PROJECT: **City of Sterling Heights – Dodge Park Improvements**
Sterling Heights, MI

DMA PROJECT NO: **16078A**

ADDENDUM NO: **3**

ISSUE DATE: **July 7, 2017**

sheet no:
LS-4 of 5

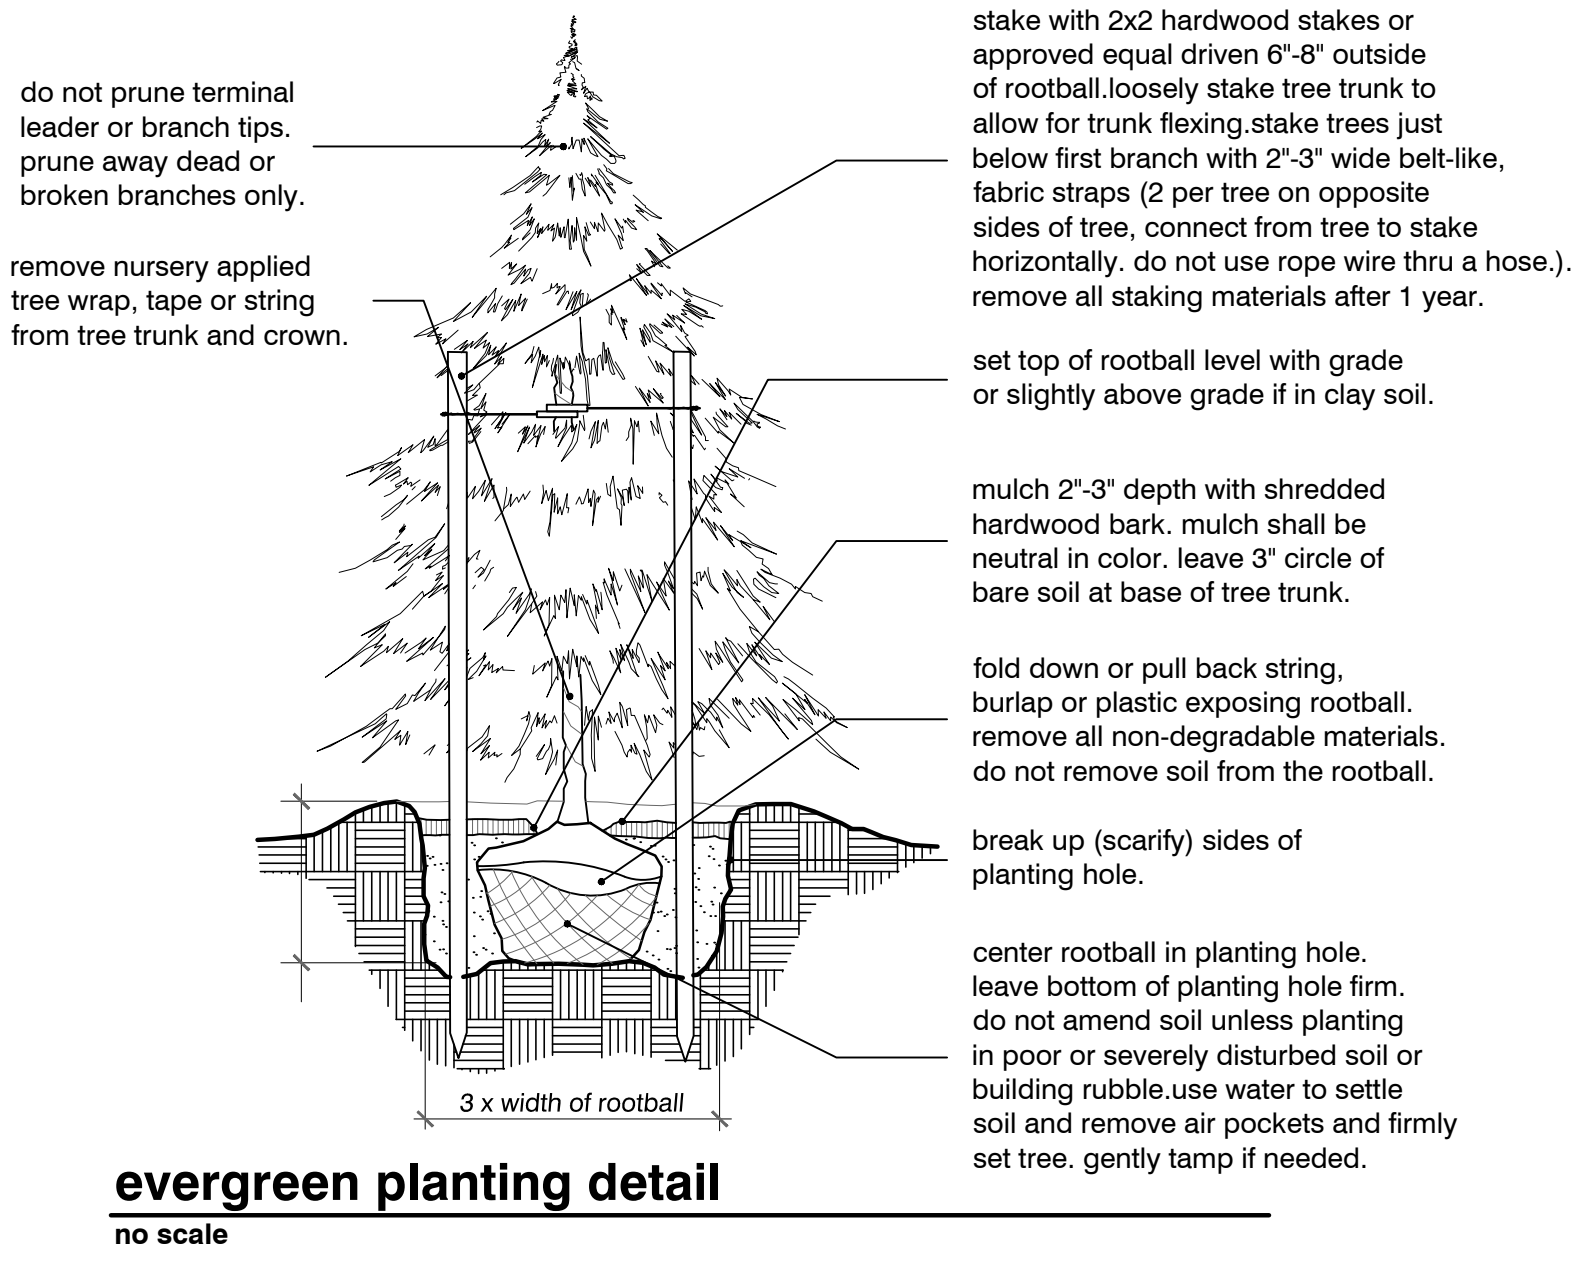
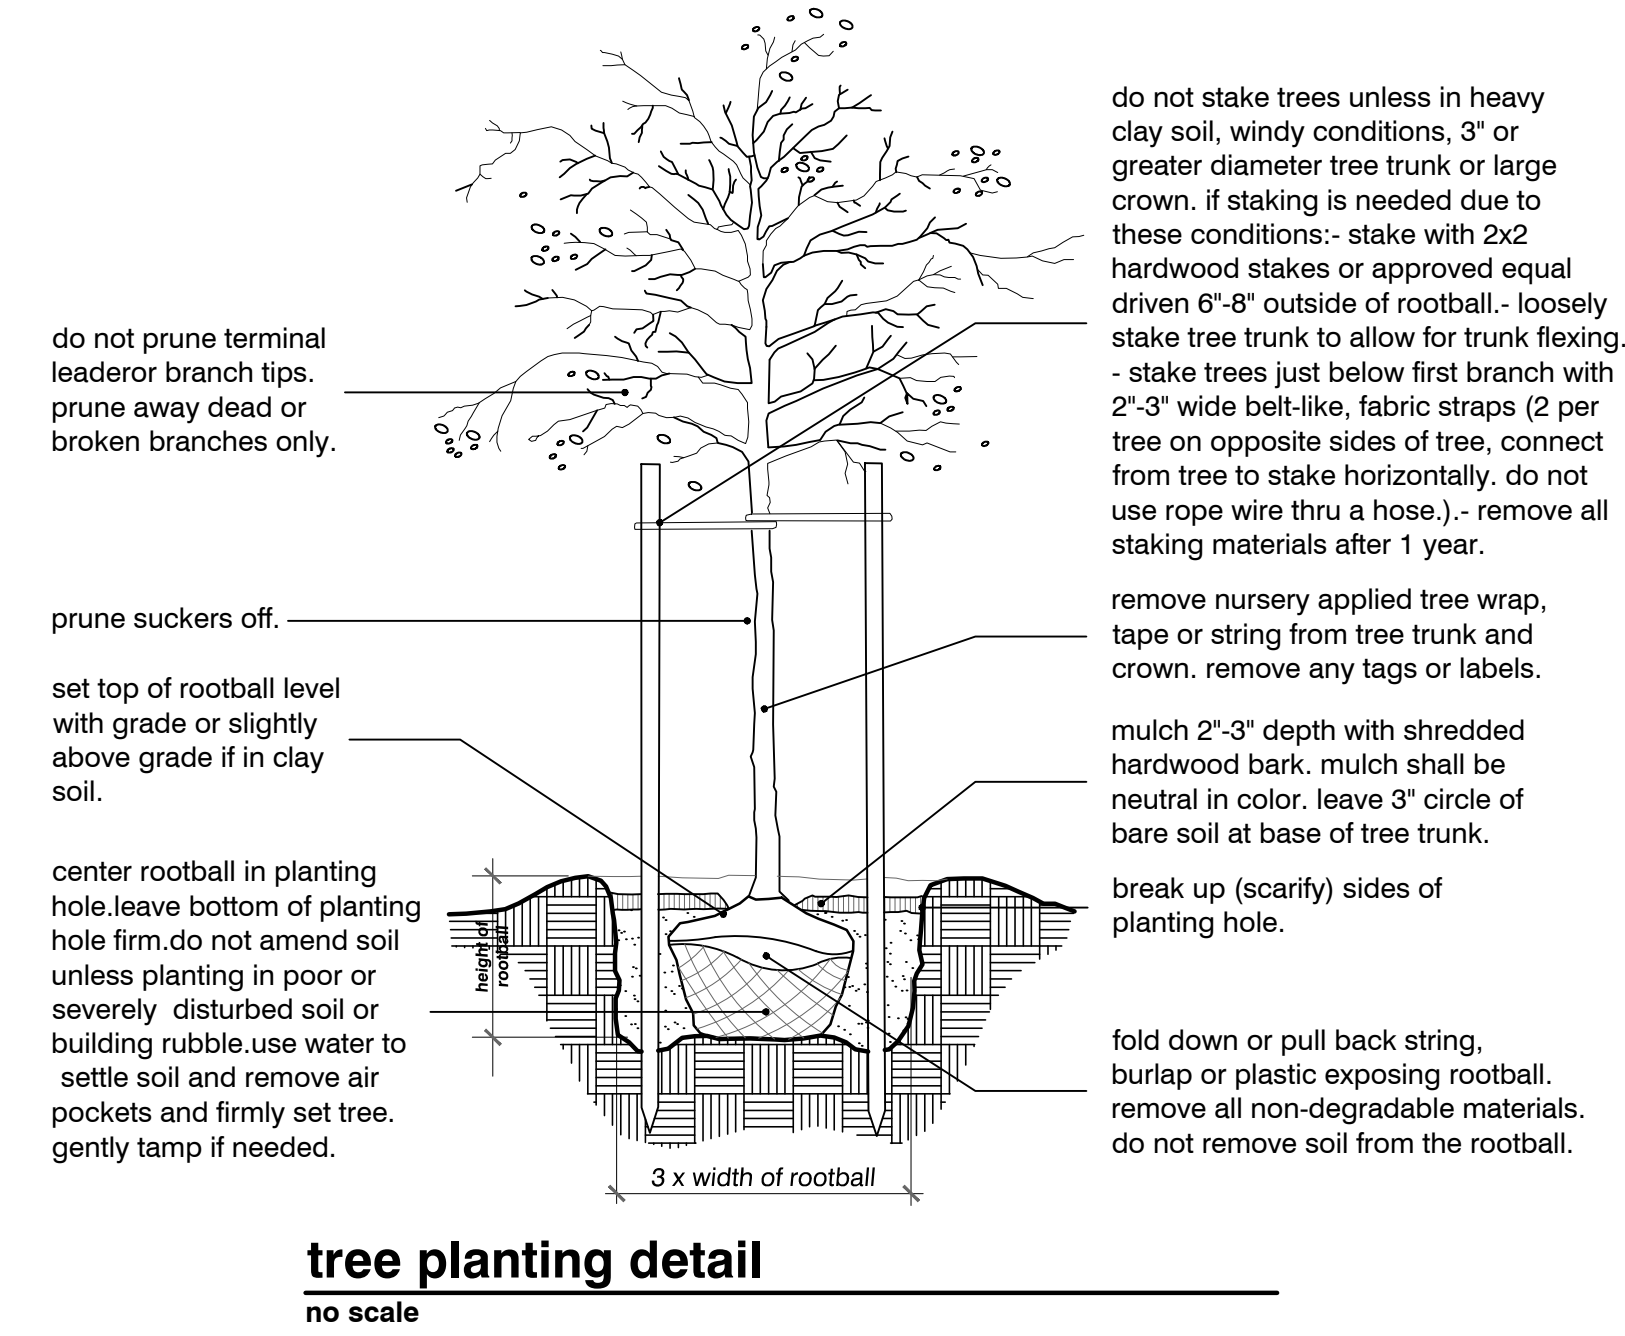
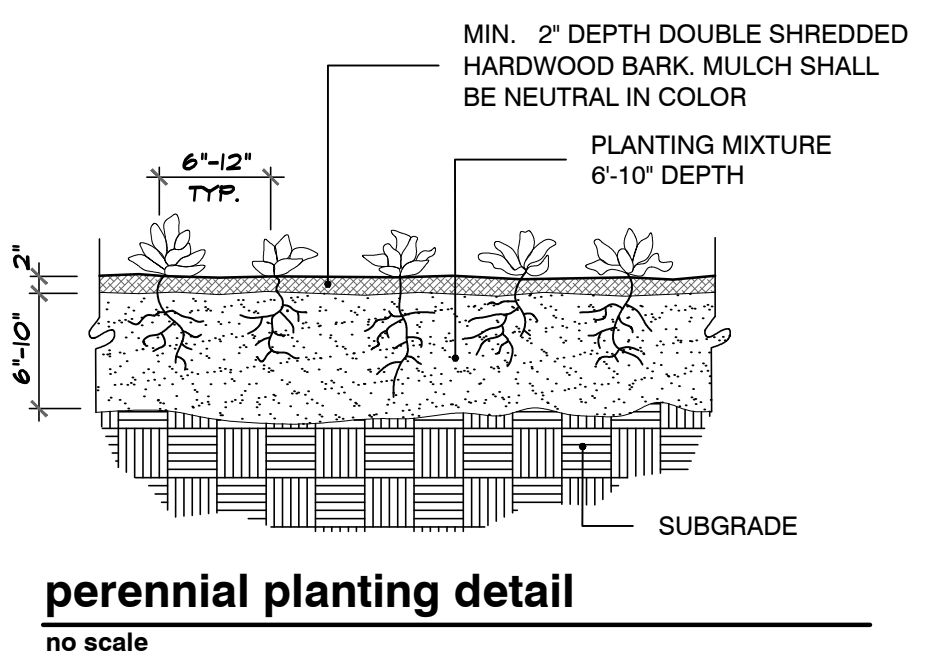
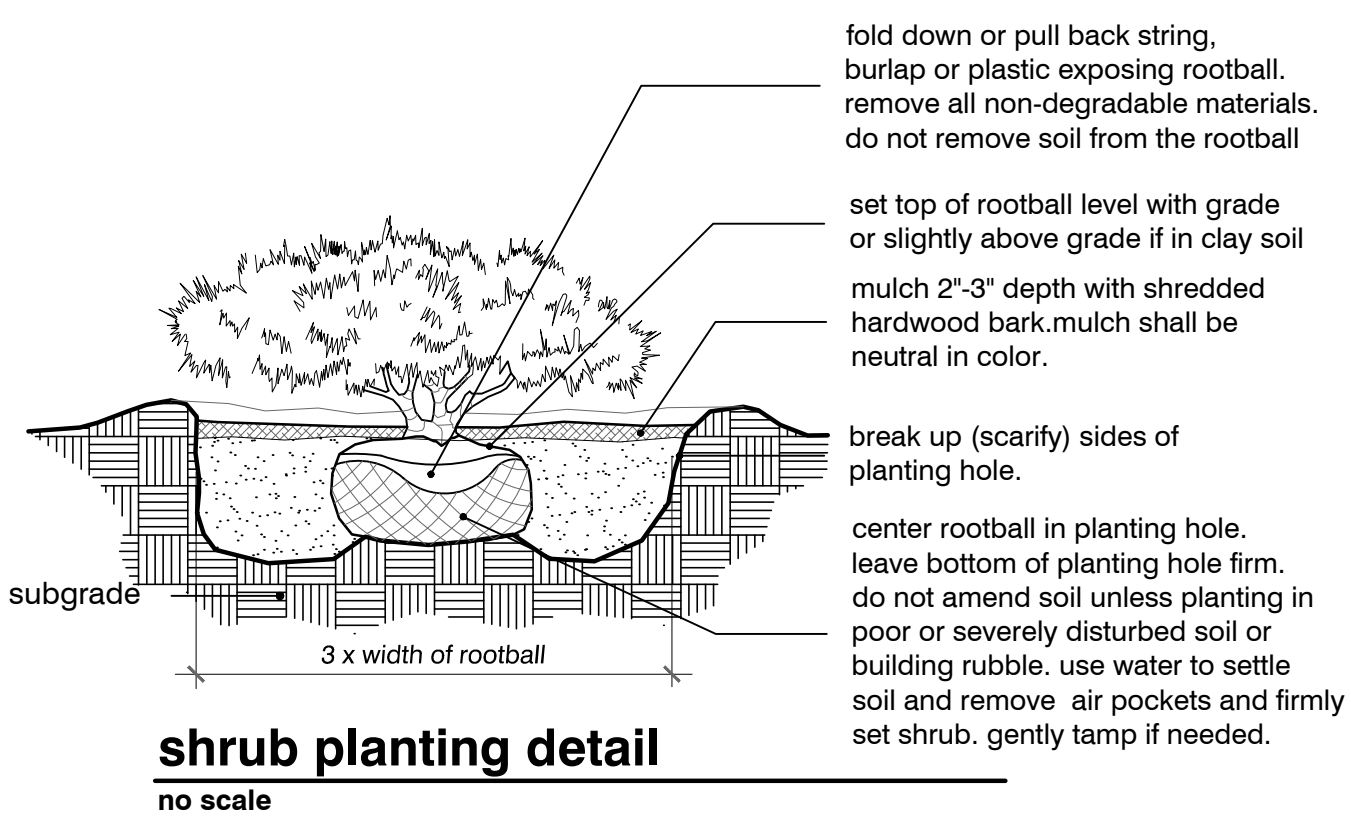
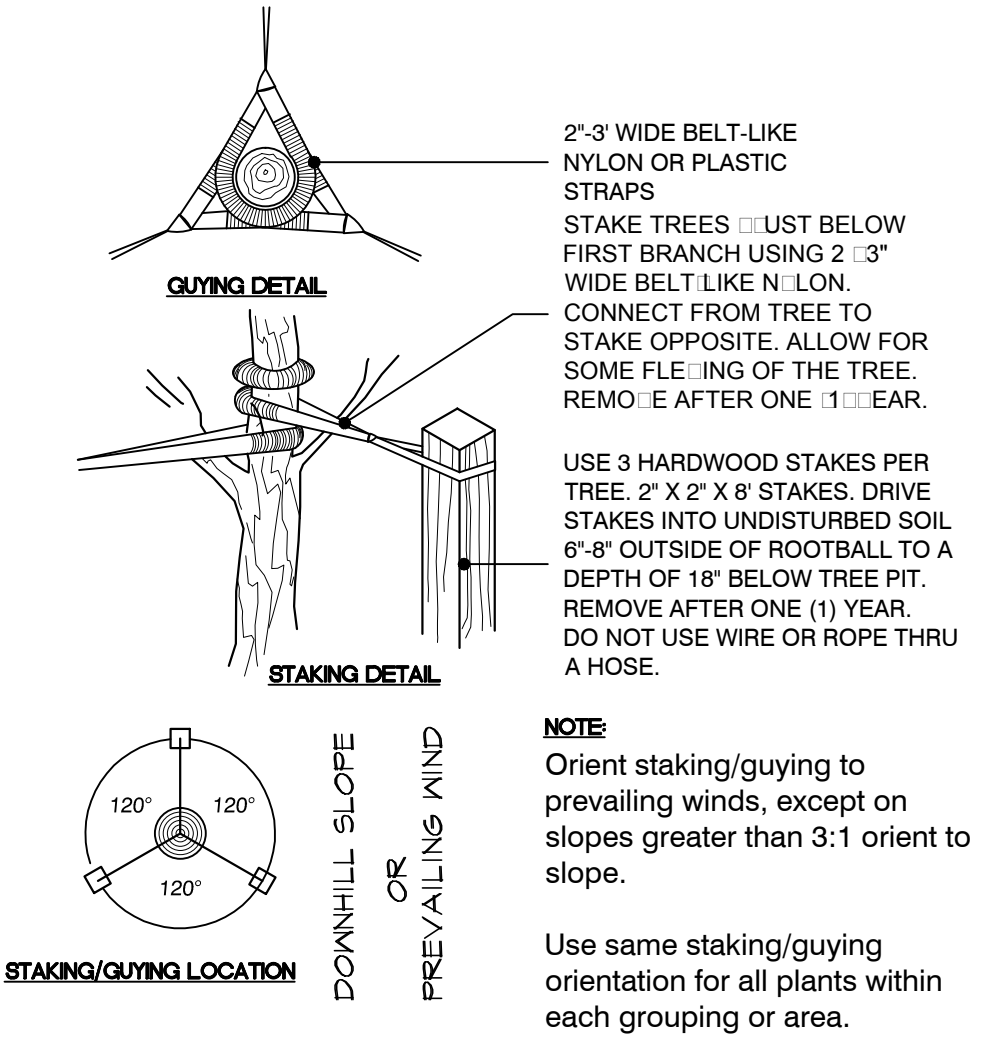
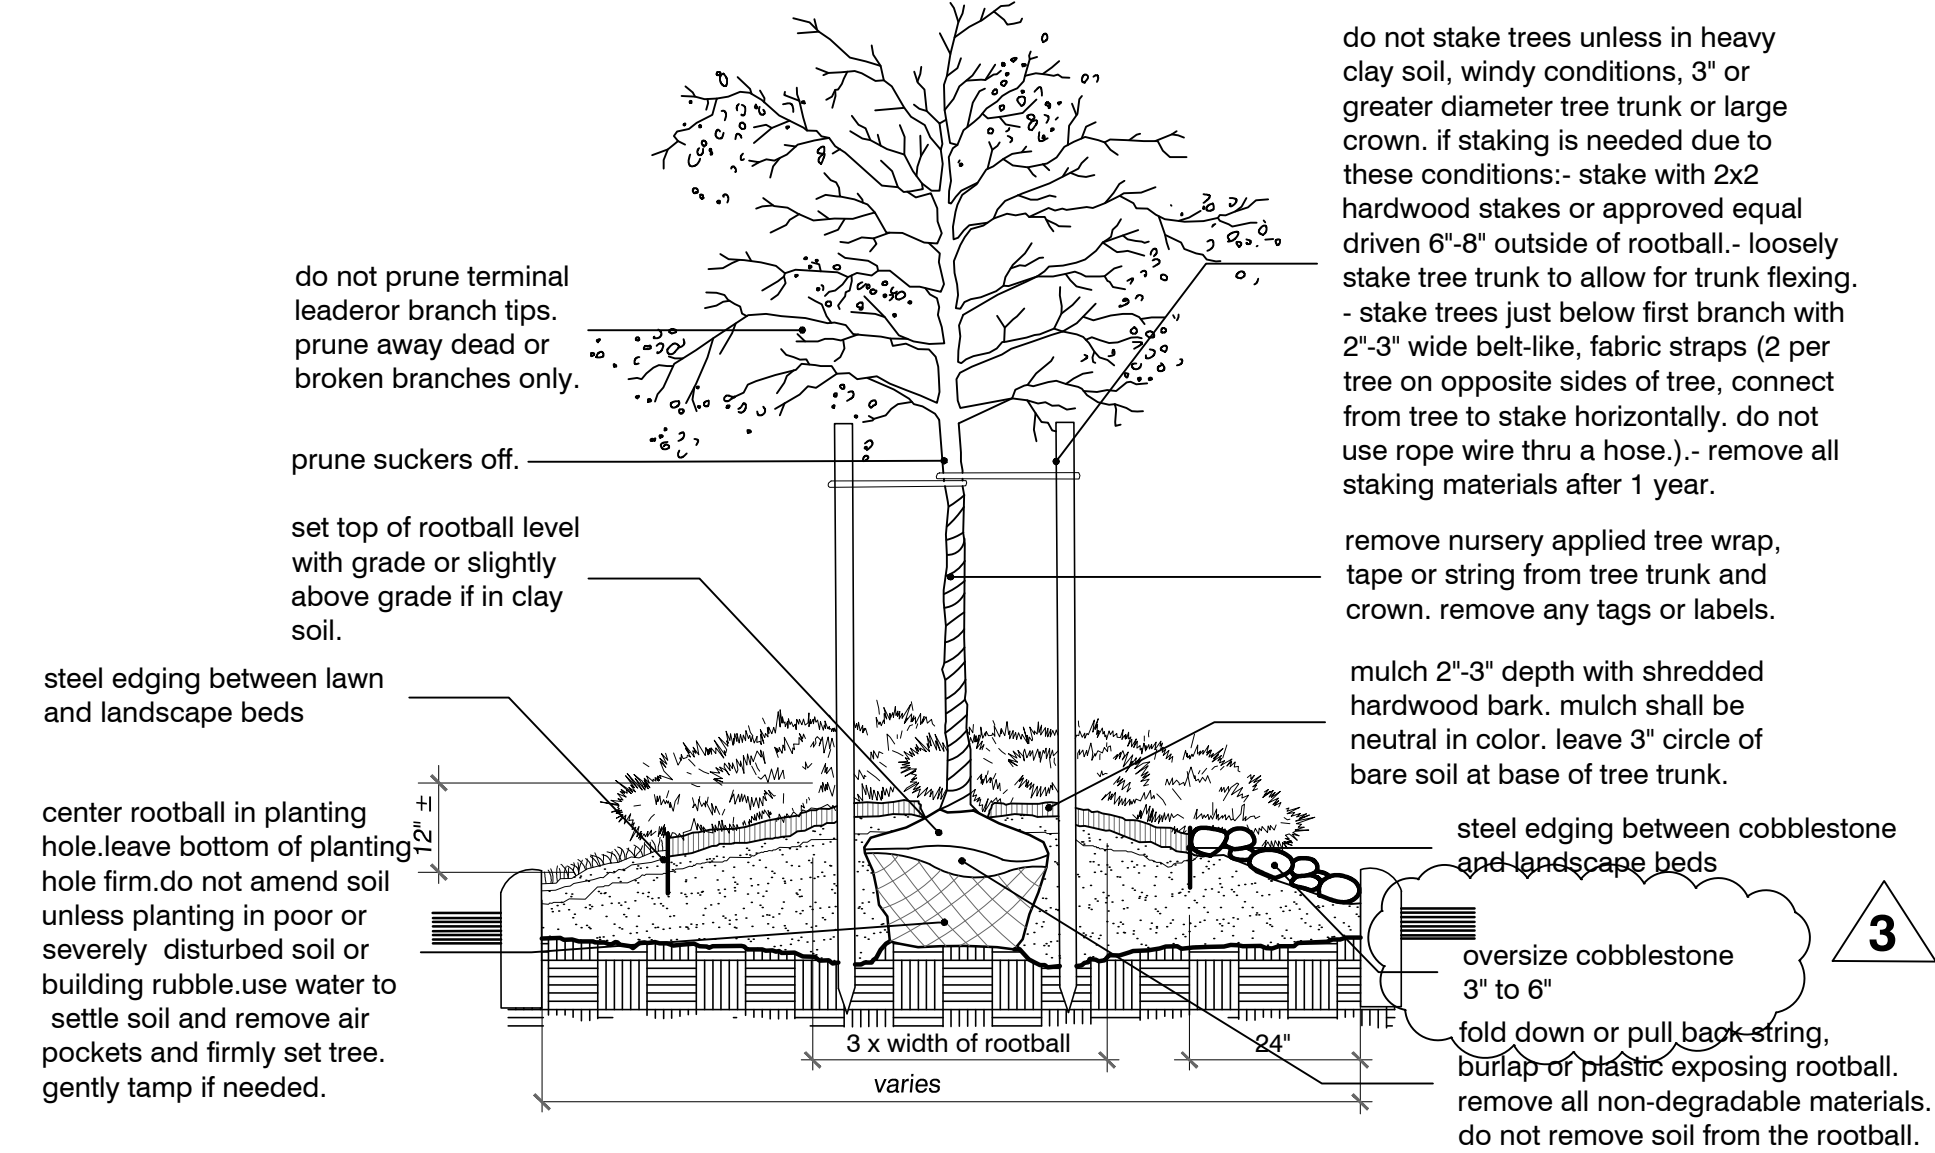
5. Revised sheet LS-4 to adjust the tree quantities due to the elimination of trees in the area to the east of the splash park.
6. Re-issue of sheet LS-5 due to a printing error that did not allow all of the material patterning to show. There have not been any revisions to this sheet.
